Appendix I

Responses to Comments on the DRAFT Water Management Plan

Lamprey River Water Management Plan

August 2013

Figure I.3 Cumulative probability distribution of water depths at Pawtuckaway Lake docks on 2 July 2011.

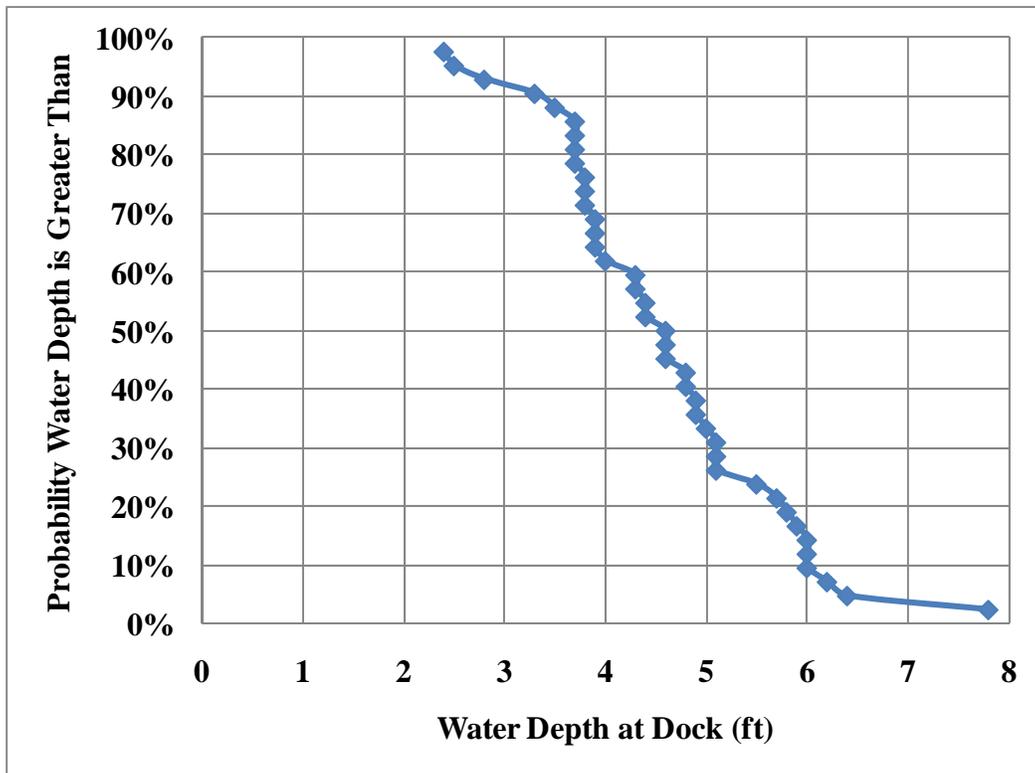
Issue: Numerous comments were received regarding the proposed reduction in the fall drawdown and the resulting higher lake levels during the winter. The majority of the commenters did not support reducing the lake drawdown during the fall and maintaining higher lake levels during the winter. The primary concerns noted in the comments were: potential changes to docks resulting from higher winter lake levels; reduced opportunities for dock and shoreline maintenance during the winter months; less destruction of aquatic invasive weeds along the shoreline; and, reduced potential for flood storage.

A field survey of dock depths was performed relative to winter ice affecting docks. UNH measured water depth at 42 docks in the southern lake area on July 2, 2011.¹ Figure I.3 displays these data which show that 59% of docks are located in a water depth of 4.8 feet or shallower. These docks will not be affected by the suggested winter drawdown of 4.8 feet. A Pawtuckaway Lake resident toured parts of the lake over New Year's Day 2012 and measured the amount of exposed lake bottom at various locations and photographed these conditions at full drawdown. DES conducted a trial of the new winter lake level beginning November 26, 2012. During the week that the lake level was held at 4.8 feet of drawdown, DES and shorefront owners examined and photographed dock conditions around the whole lake area. An estimated 25% of the docks around Pawtuckaway were in the water at this drawdown, although many of these docks were in less than a few inches of water. The Lake Level Investigation proposed to mitigate potential impacts on these docks by phasing in the new drawdown depth over a period of 4 years. This will allow affected dock owners time to assess and make changes as necessary. All seasonal docks are required by rule to be removed for five months every year at the end of boating season.

Change made as a result of comments: The change in the winter drawdown is described in an August 2013 Notice of Decision on Determination of Lake Level for Pawtuckaway Lake. According to the decision, the change in winter drawdown will be phased in over a four year period. DES will make no winter relief pulses during that time. A new baseline plant survey will be conducted in the fall of 2013.

Figure I.4 Historical assessment of lake level change as a result of relief flows

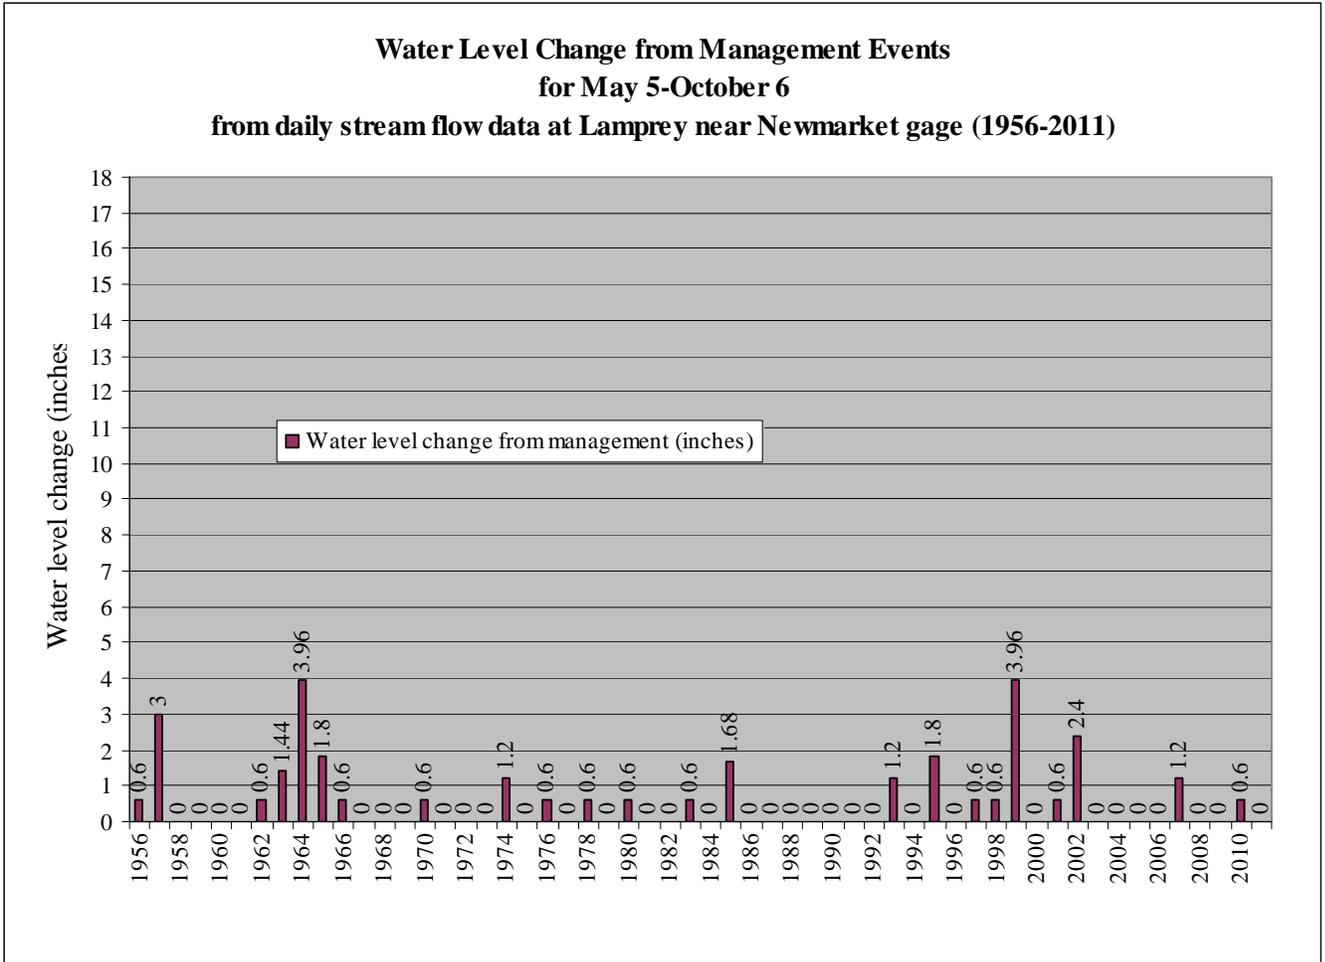
Issue: Of significant concern to the commenters is the proposal to create relief flows for the Lamprey Designated River, which would result in lower water levels in Pawtuckaway Lake during the summer. The main concerns expressed in the comments are the potential effects of lower lake levels on fish, wildlife and recreation.

Many of the stated concerns appear to be a consequence of the perception that lake levels will change frequently or by large amounts as a result of relief flows. DES's assessment of historical stream flow conditions indicate that the occurrence of summer relief flows will be rare and will be less than 4 inches due to management.

The magnitude and frequency of changes to lake levels due to hypothetical relief flows have been estimated for a 56 year period from 1956 through 2011 (see Figure I.4.). In the 56 years, there were 33 years when no relief pulses would have occurred and thirteen more years when one relief pulse each year would have occurred. During two years, six relief flows would have been applied. The change in water level from management in these worst two years was four inches.⁴ This review shows that even in the driest years, water level changes due to management would have been within the range of natural lake level fluctuations.

Changes made as a result of comments: Limits have been added to the amount of change in water level in order to protect recreational uses and habitat needs. Summertime (May 5 through October 6) water level changes will be limited to less than 18 inches below the full lake level. Water levels between May 15 and July 15 during successful loon nesting will not, as a result of management, be lowered by greater than six inches. DES and NHF&GD will develop a process and implement barriers for preventing alewife from outmigration during relief flow releases.

Figure I.6. Profile along the Fundy Cove Boat Ramp. Normal pool level is 250.4 feet.

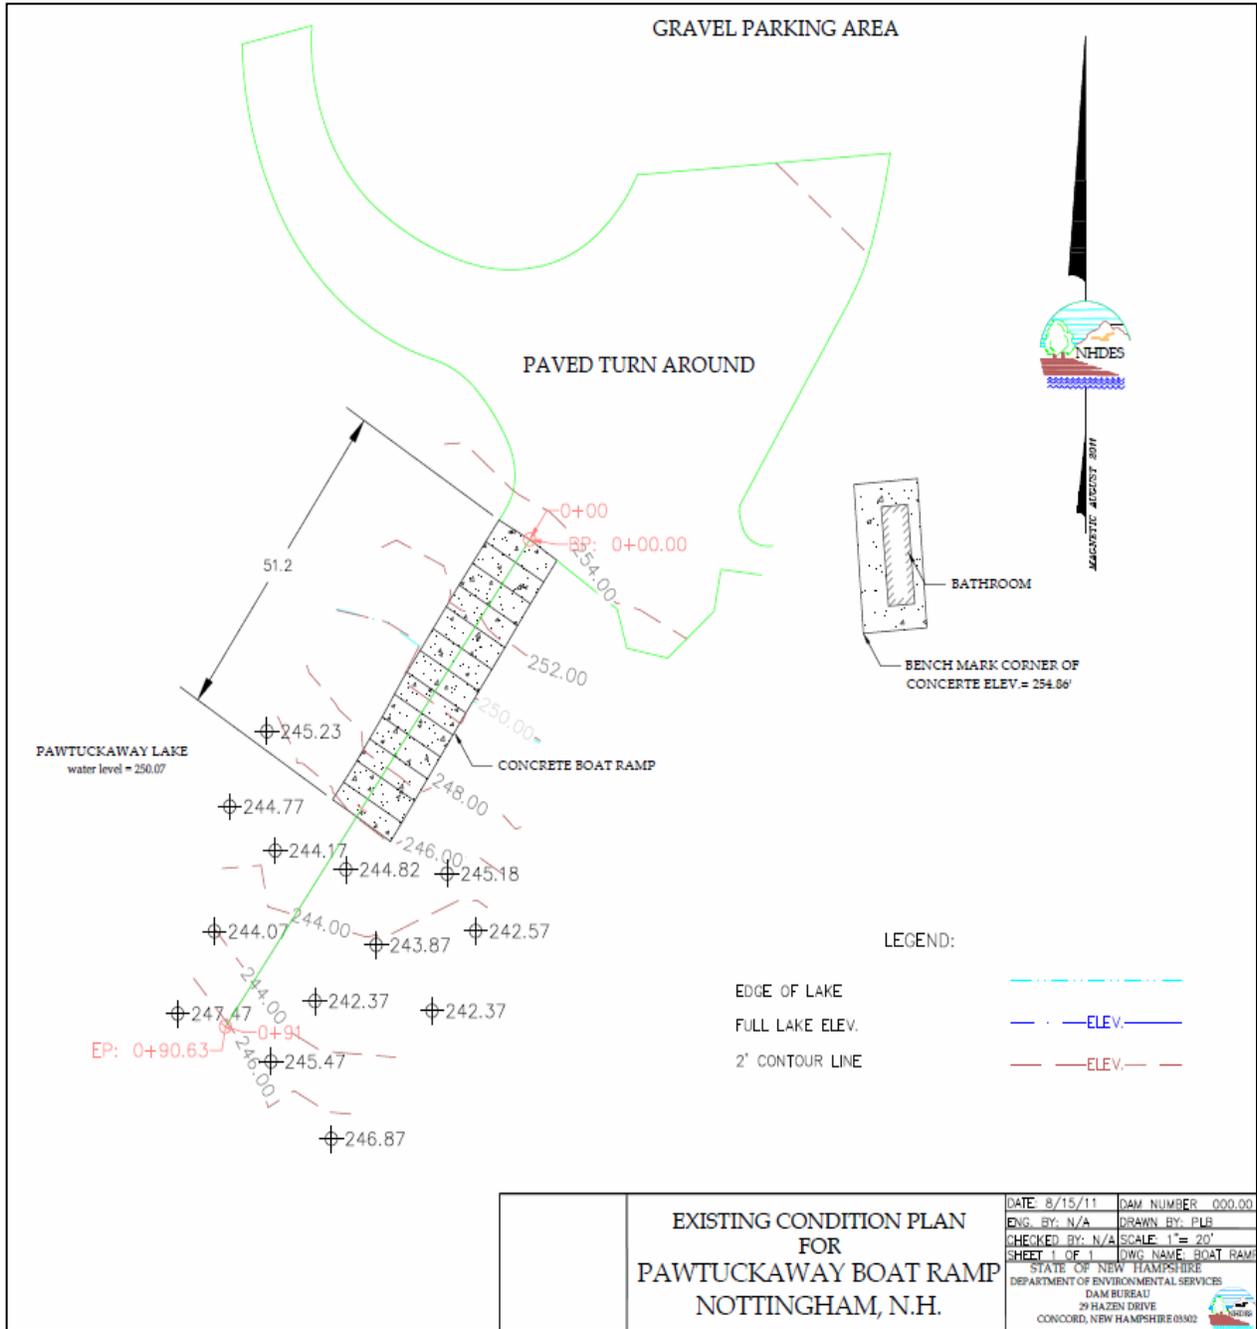
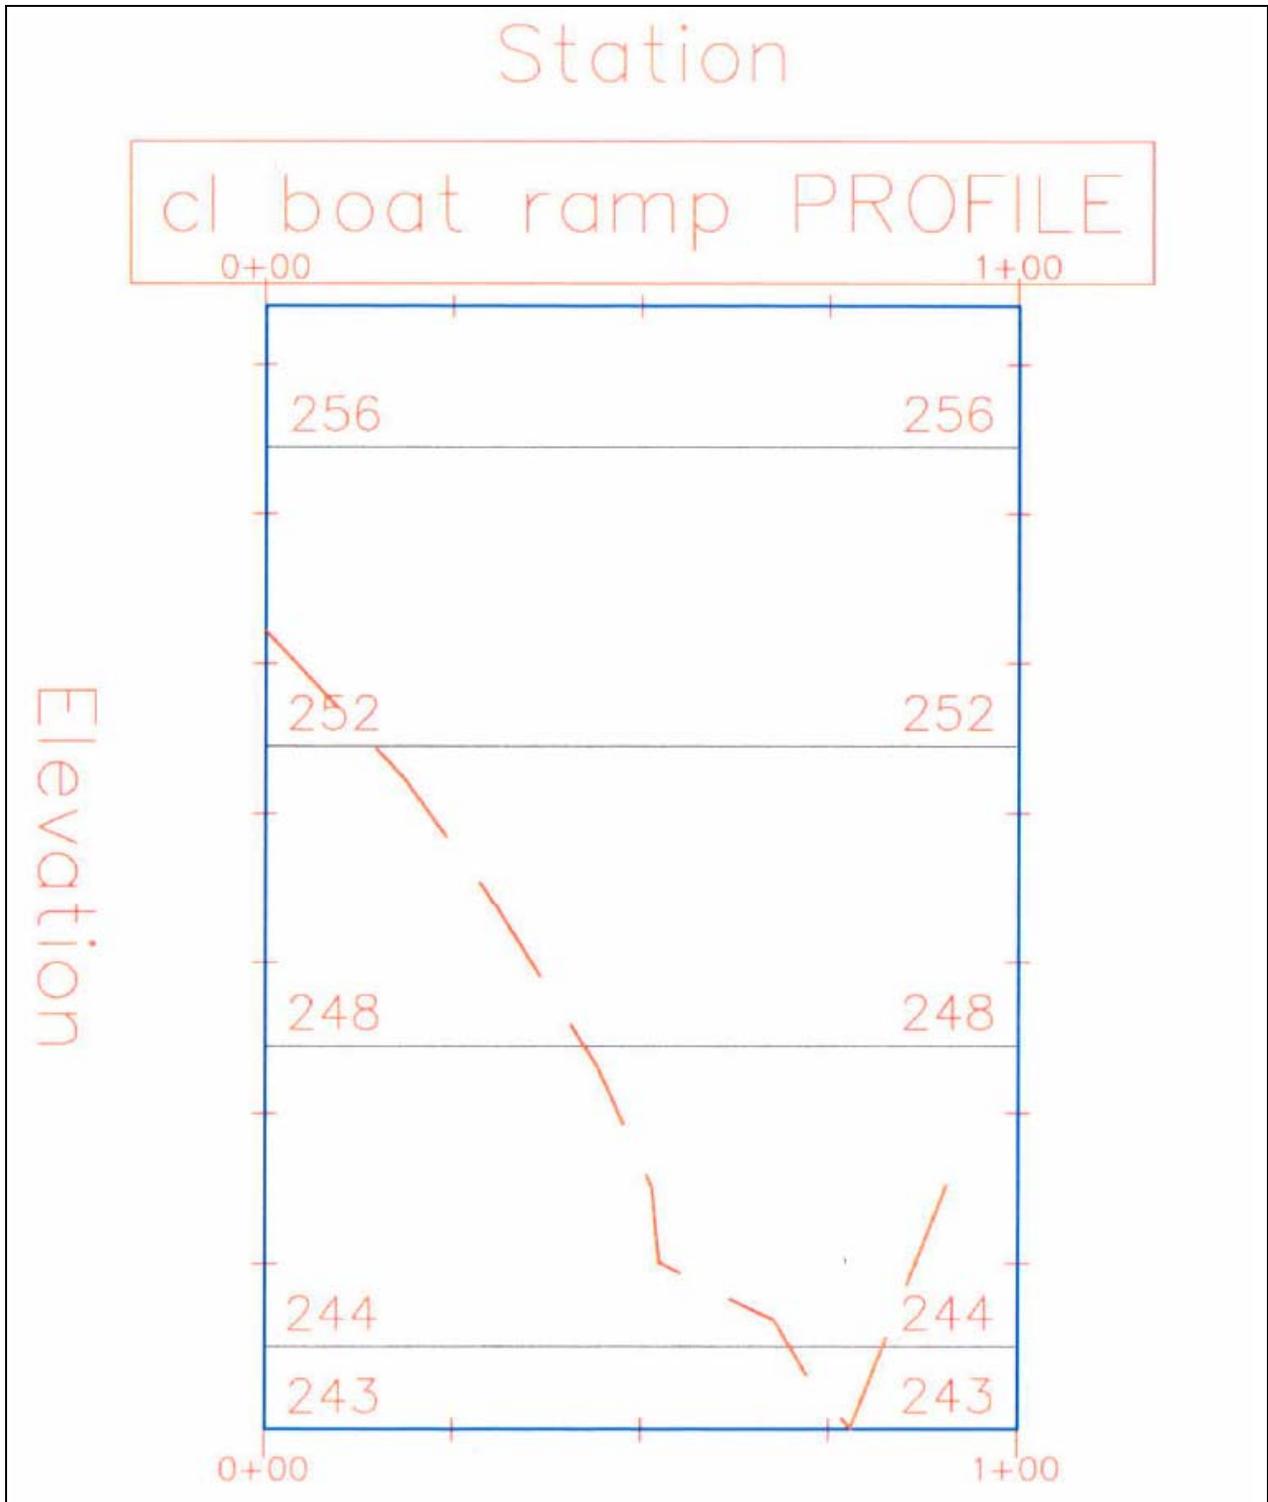
Several commenters, including NHF&GD, noted that Fundy Cove is a shallow area where the lowering of water levels could be an issue to fish and wildlife residing there and could also limit the utilization of the NHF&GD’s existing public boat ramp. As described in the previous paragraph, changes in water level from management are likely to be rare and of a sufficiently small amount as to be unlikely to affect fish or wildlife. At the best of times, Fundy boat ramp is a difficult access point. DES surveyed the boat ramp at Fundy Cove to evaluate its use from a waterbody management perspective and in terms of routine lake decline effects. Figure I.5 and Figure I.6 show the results of this survey in plan view and as a cross-section of the boat ramp. A reduction in the depth and length available for boat launching would occur if the water level is lowered 18 inches, but sufficient water depth remains for use of the boat launch—approximately 40 feet of the boat launch would be in depths of at least 2 ½ feet, and most of that distance would be over 3 ½ feet deep. This would be an extremely rare occurrence.

Figure I.7. Lamprey River Natural Relief Flow Durations 2000 – 2010.

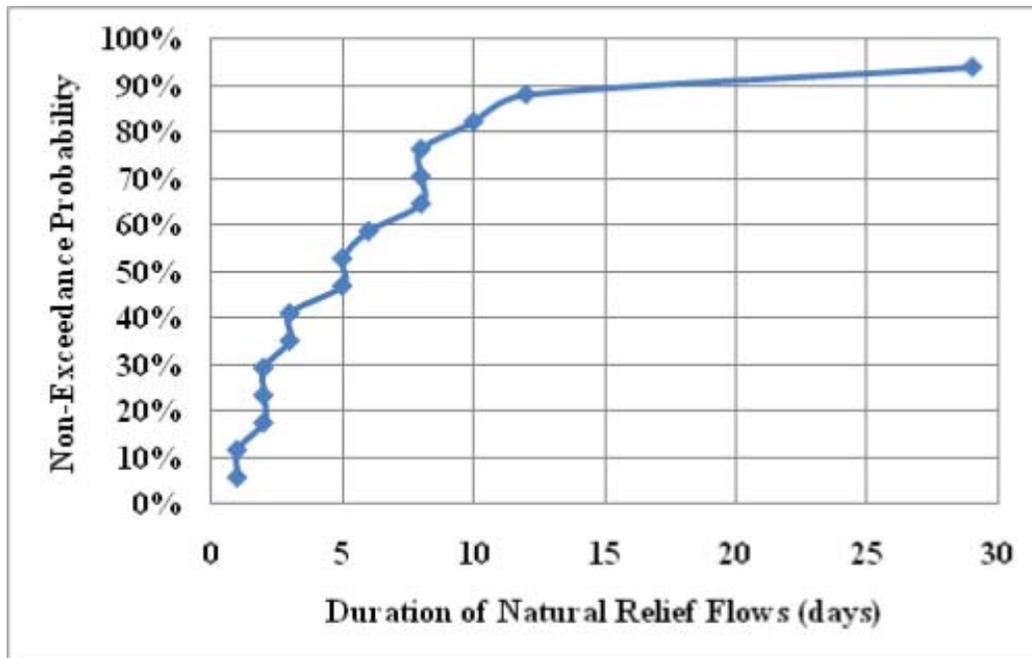
Issue: Commenters noted that the concept of relief flows was not evaluated by the Technical Review Committee and was not included in the Lamprey River Protected Instream Flow study reports. The biological rationale and efficacy of this approach was questioned along with the possible effects on Pawtuckaway Lake and Mendums Pond. It was posited that the relief flows are conceptual and untested and may be counter to the Natural Flow Paradigm. An alternative approach was also proposed, whereby the human-caused impacts on extreme low flows are quantified so that dam releases offsetting these impacts be conducted as opposed to the two-day relief flows.

Response: The relief flow concept was not presented to the Technical Review Committee as part of the Lamprey River Protected Instream Flow study because it was not part of the technical content developed during that phase of the project. The role of the Technical Review Committee was to evaluate the results of the Protected Instream Flow study and did not continue into the development of the Water Management Plan. The concepts presented in the Draft Lamprey River Water Management Plan Report were presented to and discussed with the Lamprey River Water Management Planning Area Advisory Committee (WMPAAC), which provided critical comment and recommendations.

Recreating the patterns of stream flow conditions is a major focus of protecting rivers worldwide. The duration of the relief flow was developed by studying the characteristics of the monitored river hydrograph. Figure I.7 displays the cumulative probability distribution of the duration of natural relief periods from June 20 to October 6 each year. In this figure, it can be seen that one third of the natural relief flow events last one or two days. Two days is the duration of summertime stream flow responses to small rainfall events that result in flows above the protected flow magnitudes. Longer relief flow periods might be better at supporting flow-dependent fish and other aquatic species, but doing so may unnecessarily remove water from storage.
